STATE OF RHODE ISLAND AND PROVIDENCE PLANTATION  
DEPARTMENT OF TRANSPORTATION  
RHODE ISLAND CONTRACT NO.2013-CM-026  
FEDERAL-AID PROJECT NO. FAP Nos: STP-9999(076)

**Statewide Guardrail Repair and Replacement 2013-2015**

NOTICE TO PROSPECTIVE BIDDERS

ADDENDUM NO. 1 Prospective bidders and all concerned are hereby notified of the following changes in the Plans, Specifications, Proposal and Distribution of Quantities for this contract. These changes shall be incorporated in the Plans, Specifications, Proposal and Distribution of Quantities, and shall become an integral part of the Contract Documents.

**TERMINAL END SECTION (SINGLE FACE), RI STD 34.3.2**

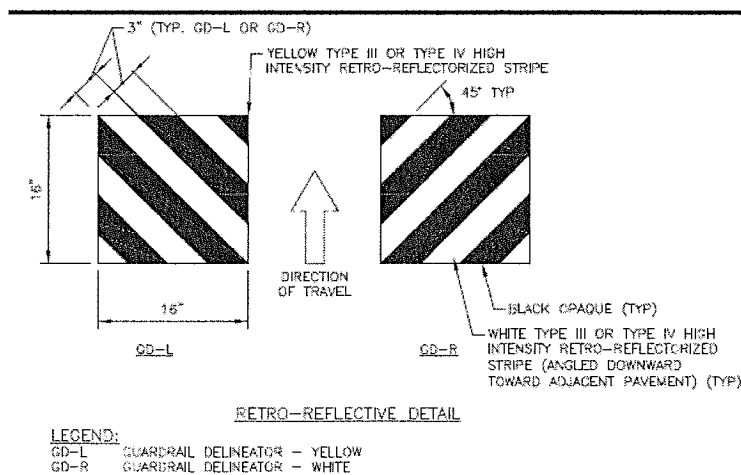
Remove page JS-60 in its entirety and replace it with revised page JS-60(R-1) and insert new page JS-60a attached to this Addendum No. 1. The Materials and Basis of Payment sections have been modified for Item Code 901.9942 "Terminal End Section (Single Face), RI STD 34.3.2". The Construction Method section has been added for Item Code 901.9942 "Terminal End Section (Single Face), RI STD 34.3.2".

**MATERIALS:** Materials shall conform to the applicable requirements of subsection M of the Standard Specifications, as amended and all Compilations of Approved Specifications.

The guardrail end terminal delineator shall be an adhesive-coated yellow or white reflective sheeting applied with a pressure sensitive adhesive backing. The reflective sheeting shall be Type III high or Type IV high intensity retro-reflective sheeting. The reflective sheeting shall have a smooth weather-resistant outer surface, and shall have a pre-coated pressure-sensitive adhesive, which will adhere to a flat steel or aluminum backing. The adhesive shall have no staining effect on the reflective sheeting, and shall be mildew resistant. All materials shall be subject to the approval of the Engineer. Reference the drawing below.

The guardrail end terminal delineator is to be installed on the nose of the guardrail terminal end section with adhesive in accordance with the manufacturer's recommendations and in accordance with this specification. The delineator shall cover the nose of the guardrail terminal end section, and the width of the sheeting shall be installed at the center of the nose curvature. In cases where the delineator is too large, the delineator shall be cut to match the guardrail terminal end.

**THRIE BEAM TERMINAL END (SIMILAR TO RI STD 34.3.2)**

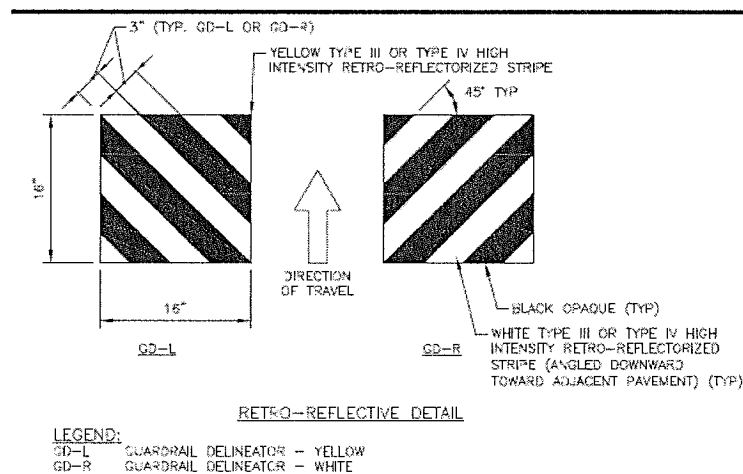
Remove page JS-61 in its entirety and replace it with revised page JS-61(R-1) and insert new page JS-61a attached to this Addendum No. 1. The Materials and Basis of Payment sections have been modified for Item Code 901.9943 "Thrie Beam Terminal End (Similar to RI STD 34.3.2)". The Construction Method section has been added for Item Code 901.9943 "Thrie Beam Terminal End (Similar to RI STD 34.3.2)".

**MATERIALS:** Materials shall conform to the applicable requirements of subsection M of the Standard Specifications, as amended and all Compilations of Approved Specifications.

The guardrail end terminal delineator shall be an adhesive-coated yellow or white reflective sheeting applied with a pressure sensitive adhesive backing. The reflective sheeting shall be Type III high or Type IV high intensity retro-reflective sheeting. The reflective sheeting shall have a smooth weather-resistant outer surface, and shall have a pre-coated pressure-sensitive adhesive, which will adhere to a flat steel or aluminum backing. The adhesive shall have no staining effect on the reflective sheeting, and shall be mildew resistant. All materials shall be subject to the approval of the Engineer. Reference the drawing below.

The guardrail end terminal delineator is to be installed on the nose of the guardrail terminal end section with adhesive in accordance with the manufacturer's recommendations and in accordance with this specification. The delineator shall cover the nose of the guardrail terminal end section, and the width of the sheeting shall be installed at the center of the nose curvature. In cases where the delineator is too large, the delineator shall be cut to match the guardrail terminal end.
